Site Survey of Selected Items  
for  
Compliance with the Americans with Disabilities Act  
(ADAAG)  
and  
Title 24 of the CBC

This report identifies noncompliant items in new construction and provides recommended methods for removal of the barriers identified.

The site survey of Ellen Ochoa Learning Center was conducted on February 27, 2007 during a spot check for compliance with the Americans with Disabilities Act Guidelines (ADAAG) and Title 24 of the CBC

# Facility Name: Ellen Ochoa Learning Center

Gate from Florence Avenue Parking to School

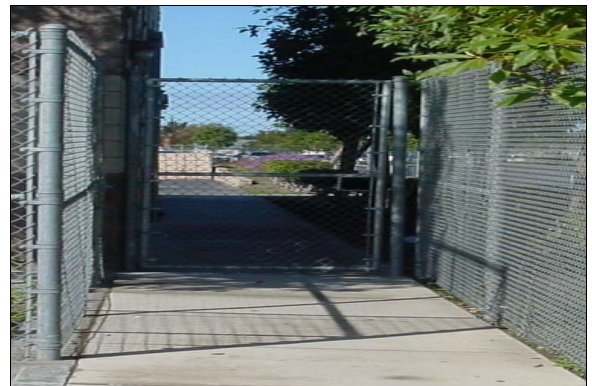
**Finding:** The bottom 10 inches of the gate does not provide a smooth, uninterrupted surface, or panel to allow the door to be opened by a wheelchair footrest without creating a trap or hazardous condition.

**Full Rec** Install a panel or replace the gate to provide a smooth, uninterrupted surface for the bottom 10 inches of the door.

Directional Signage

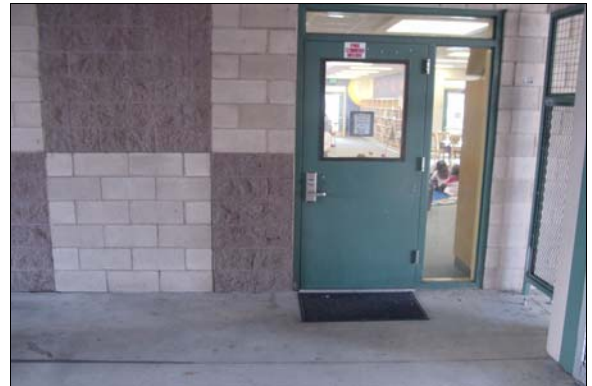
**Finding:** There is no directional signage to the classrooms or other common use areas.

**Full Rec** Install directional signage to each common area complying with CBC 1117B.5 and ADAAG 4.30.
